NIAGARA OFFICIAL PLAN

Appendix 5 - PDS 06-2022

Updated – Urban Settlement Area Assessment Review
and Comments

Niagara Region
March 9, 2022

SABR ID: 1007

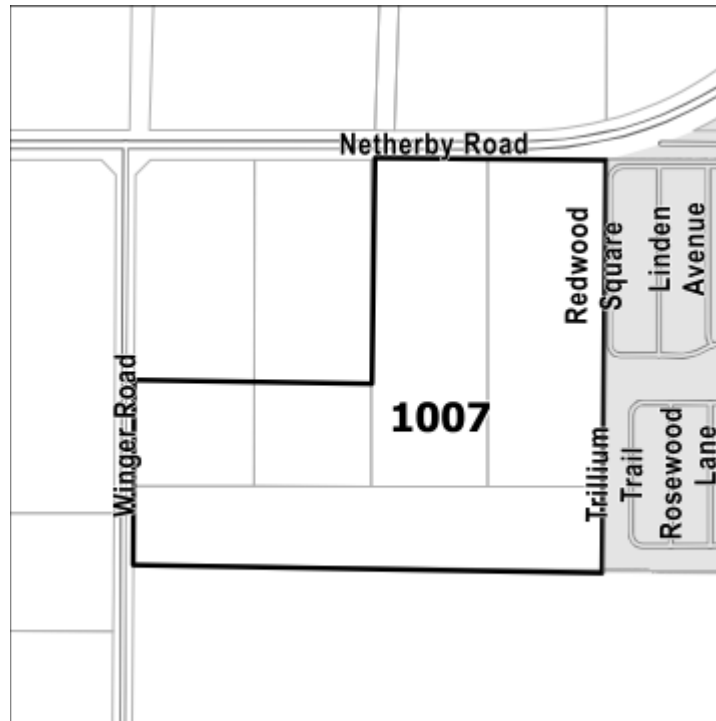
Comment: Low/Less Feasibility - some limited availability for growth capacity, not realistic to expand upon treatment system capacity, would need to connect to Anger Ave or Potentially the new SNF WWTP, wet weather issues in Fort Erie

Comment: New extensive collection system required, would require significant trunk infrastructure, no gravity outlet available

Comment: Appears to have env and agri features present

Comment: Has a Regional trunk watermain adjacent to it but would require a local distribution system - Additional storage in FE being studied

Comment: Located along/nearby the identified route for the future NGTA corridor. Convenient access to the QEW via RR 25 Netherby Road, which is planned for future operational improvements per the 2017 TMP. Good access to Regional roads including RR 25 Netherby Road which borders the subject lands, as well as the nearby RR 116 Stevensville Road/Sodom Road.

Comment: Until the alignment for the NGTA corridor is known, a local road network cannot be easily established without risking major impact in the future.

Comment: Per the 2017 TMP, future improvements are planned on RR 25 Netherby Road west of the QEW, and on RR 116 Sodom Road north of RR 25 Netherby Road. Further improvements may be required to improve access to the future NGTA corridor. Intersection improvements would appear to be needed at Winger Road and RR 25 Netherby Road.

Comment: Watercourse bisects parcel and crossings may be required

Comment: Site 1007 is in the watershed planning area FE-1 and is assessed as modest impact.

Comment: There are nearby livestock operations. Further MDS review may be required

Comment: The ability to meet community land need for the municipality by inclusion of these lands is generally lower given the size of the site. If there were certainty related to the broader candidate lands being included, there collectively there would be a more favourable impact. On their own, they remain lower.

SABR ID: 1064

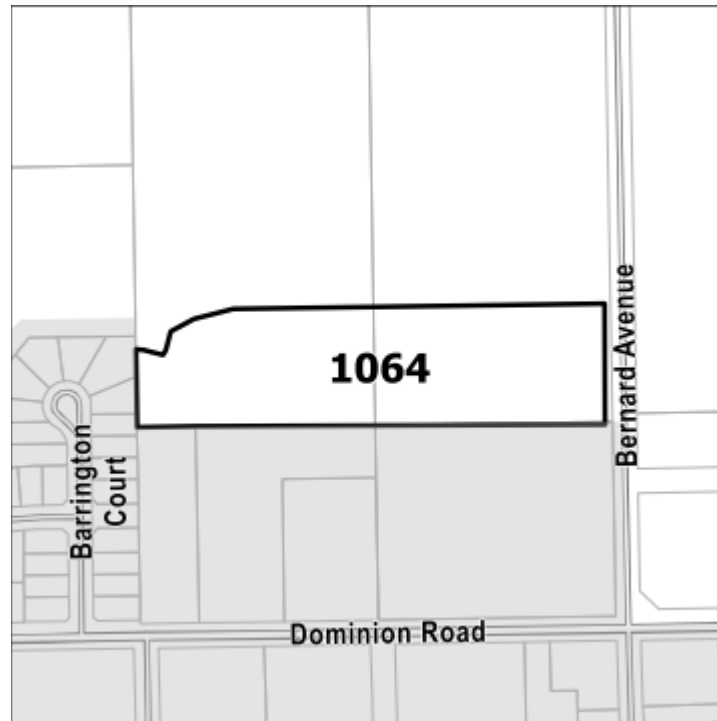
Comment: Some growth capacity available at Crystal Beach WWTP but additional growth beyond these lands may require capacity expansion

Comment: Within the Shirley Rd SPS - plans for capacity expansion, need to review servicing plan to ensure elevations and downstream capacity available, new sewer collection system required, wet weather issues in Fort Erie

Comment: Relatively close access to Provincial Highway 3. Access to QEW is further but several Regional roads provide connections. Easily accessible by RR 1 Dominion Road.

Comment: Located in close proximity to the Friendship Trail, with connections possible. Existing cycling facilities on RR 1 Dominion Road, which provide connection to urban areas and recreational destinations to the west and west. Some infill cycling facilities planned to the east as per 2017 NR TMP which will improve connections to the north and south.

Comment: Mapped and unmapped features may impact access

Comment: Site 1064 is in the watershed planning area FE-2 and is assessed as a modest impact

Comment: This site appears to have a livestock operation to the north. Further MDS review may be required

Comment: Site 1064 is on the edge of an area of known deposits of mineral aggregate resource. Site 1064 is not within 1000m of an existing mineral aggregate operation. Although the site is on a known deposit of mineral aggregate resource the rural development patterns to the north mean that a new mineral aggregate operation is highly unlikely and the impacts are negligible.

Comment: The lands are characterized more in keeping with a rounding out existing settlement area and are smaller in size and limited to the natural features along its northerly limits. That lands identified within provincial Natural

Comment: Addition of these lands is assessed as favourable for contribution to land need and from the perspective of limited locations in the easterly portion of this particular settlement area might see expansion potential. Single or few owners assists in process potential.

SABR ID: 1072

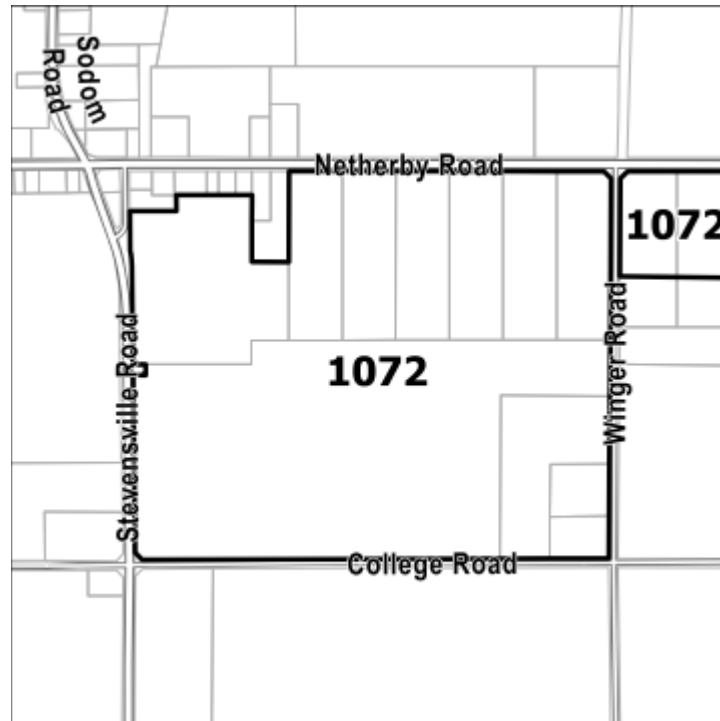
Comment: Low/Less Feasibility - some limited availability for growth capacity, not realistic to expand upon treatment system capacity, would need to connect to Anger Ave or Potentially the new SNF WWTP, wet weather issues in Fort Erie

Comment: new extensive collection system required, would require significant trunk infrastructure, no gravity outlet available

Comment: Located along/nearby the identified route for the future NGTA corridor. Access to the QEW is provided on RR 25 Netherby Road via the collector road Winger Road. Per the TMP, RR 25 Netherby Road is planned for future operational improvements. Fairly good Regional road access with RR 25 Netherby Road and RR 116 Stevensville Road located nearby.

Comment: The section of Eagle Street west of Winger Road would appear to require reconstruction to accommodate development, depending on anticipated traffic levels. Further road improvements may be required to improve access to the future NGTA corridor.

Comment: For the northern part of the requested land: Limited existing cycling facilities. Per the 2017 TMP, the railway spur line to the south could be a candidate location for infill cycling facilities in the form of a multi-use trail, and would be relatively accessible from the subject lands. The 2020 FE ATMP identifies buffered paved shoulders on Netherby Road and Stevensville Road. The future NGTA corridor could present a barrier for active transportation, and connections will require planning once its alignment is known. Note: This parcel has been removed from the SABR Map.

Comment: Outside PNHS - small portion of watercourse in north-east corner

Comment: Portions of request area are close to existing livestock operations. Further MDS review may be required.

Comment: Similar comments pertain concerning Highway corridor. With respect to this particular site, it would also be reliant on other lands being added to either Stevensville or Douglastown in order to be a contiguous location to an existing settlement area. Without defined ROW limits the prospect of addition from Stevensville is not foreseen. Potential for some northerly lands being adjoined from Douglastown, however requires intervening lands being added. The status of the highway corridor effectively reduces any certainty on how these lands could potentially be considered.

Comment: As outlined above, the uncertainty of highway ROW location precludes accurate assessment. The size of the area being assessed would undoubtedly offer considerable potential in addressing municipal land need, however until such time as an ROW is identified by the Province, detailed planning of community could not be achieved. The assessment of these lands reflects that uncertainty.

Comment: Impact on neighbouring or nearby lands if these lands to where be included would be assessed as being minimal. However, impact from the highway corridor has essentially eliminated any potential for consideration as part of this MCR.

SABR ID: 1116

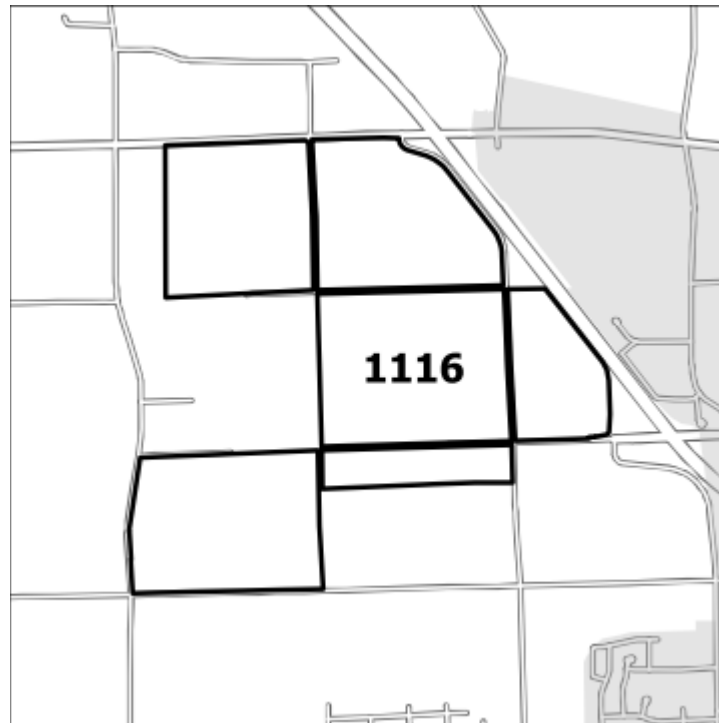
Comment: Low/Less Feasibility - no direct outlet to an existing WWTP - would need to go to Anger Ave WWTP - some availability for growth capacity

Comment: Less Feasible - SPS required with QEW crossing, need to review downstream system and potential upgrades, would require significant trunk infrastructure depending on servicing plan, no gravity outlet available, wet weather issues in FE

Comment: Less Feasible - QEW crossing for new watermain, required looping, needs extension of watermains and distribution network - Review of fire flow and capacity required - Additional storage in FE being studied, need to review fire flows

Comment: Proximity of this collection of parcels next to the QEW between two full access interchanges affords it the highest level of access. Good Regional road connections with RR 19 Gilmore Road and RR 21 Bowen Road in close proximity.

Comment: RR 21 Bowen Road was recently reconstructed and would serve the northern parcels well. However reconstruction of Gilmore Road west of the QEW would appear necessary to serve the southern parcels, and the road could be a candidate for upgrading to the Region (currently it is a Regional Road only east of the QEW). Depending on the size of the development and the amount of site traffic to be generated, collector roads in area may require some improvements.

Comment: PNHS runs through middle of area - corridor function to be considered

Comment: Access is limited due to scope and location of ENV features - corridor function needs to be considered

Comment: Site 1116 is in the watershed planning area FE-3 and is assessed as a high impact.

Comment: More significant grade changes in NW quadrant

Comment: Site 1116 is a number of parcels. Site 1116 is within an area of known deposit of mineral aggregate resource. Site 1116 is adjacent and within 1000m of an existing mineral aggregate operation. The score of critical is given based on the most sensitive land use. If an employment use is proposed which may be compatible with the existing mineral aggregate operation - the score could be reconsidered.

Comment: Addition of these lands from east to west in sequential manner would act in addressing identified land need for employment purpose. Consideration should be given to lands north of Bowen in conjunction with overall land need and may reduce what would be required from this large land assembly in order to meet forecasts. For the purposes of assessment, this site

SABR ID: 1127

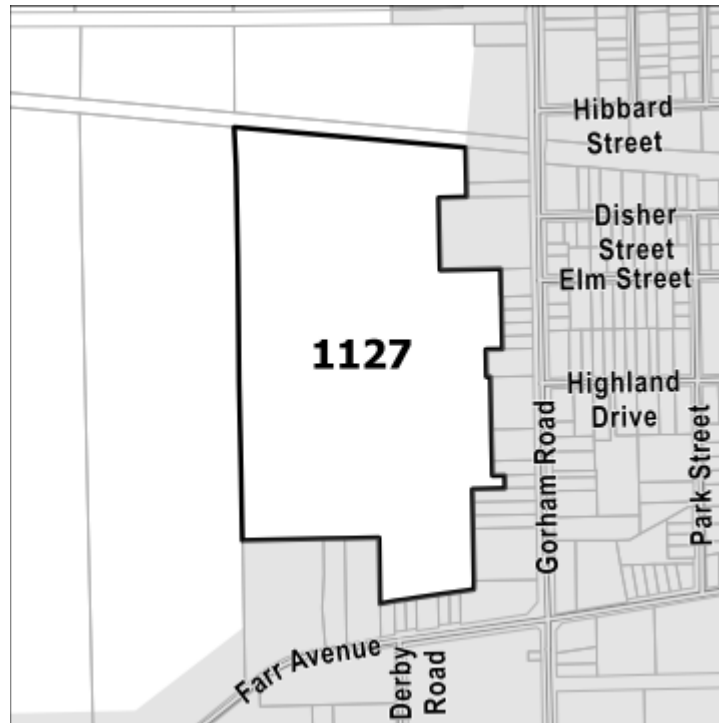
Comment: Some growth capacity available at Crystal Beach WWTP but additional growth beyond these lands may require capacity expansion

Comment: Need to review servicing plan to ensure elevations and downstream capacity available, new sewer collection system required, wet weather issues in Fort Erie

Comment: could support some additional lands but depends on servicing plan and capacity review of collection system
